RESPONSE TO SUBMISSIONS REPORT

PROPOSED CATHOLIC COLLEGE 2 KINGFISHER CLOSE AND 507 MEDOWIE ROAD, MEDOWIE LOT 412 AND LOT 413 DP 1063902

Prepared on behalf of:
TRUSTEES OF THE ROMAN CATHOLIC CHURCH FOR THE DIOCESE OF MAITLAND – NEWCASTLE

NOVEMBER 2018

Figure 2 – Averaging rule (source: DPI 2012)

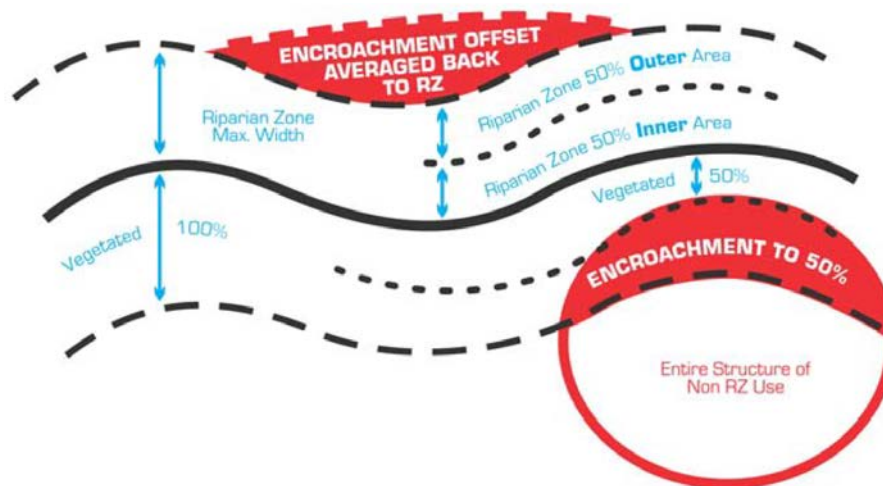
Non riparian corridor works and activities can be authorised within the outer riparian corridor, so long as the average width of the vegetated riparian zone can be achieved over the length of the watercourse within the development site. That is, where appropriate 50 per cent of the outer vegetated riparian zone width may be used for non-riparian uses including asset protection zones, recreational areas, roads, development lots and infrastructure. However, an equivalent area connected to the riparian corridor must be offset on the site (see Figure below) and the inner 50 per cent of the vegetated riparian zone must be fully protected and vegetated with native endemic riparian plant species.

Bridges, cycleways, paths, stormwater outlets and other essential services do not need to be offset, but must comply with the requirements set out in the riparian corridor matrix (Table 2) and other relevant Office of Water controlled activities guidelines. Offline detention basins do not need to be offset so long as there is an equivalent VRZ for the corresponding watercourse and they are built in compliance with the Office of Water's Controlled activities: Guidelines for watercourse crossings and Controlled activities: Guidelines for in-stream works. If a proposed basin will not have an equivalent VRZ for the corresponding watercourse, it may still be built in the outer 50 per cent of the VRZ but must be offset.
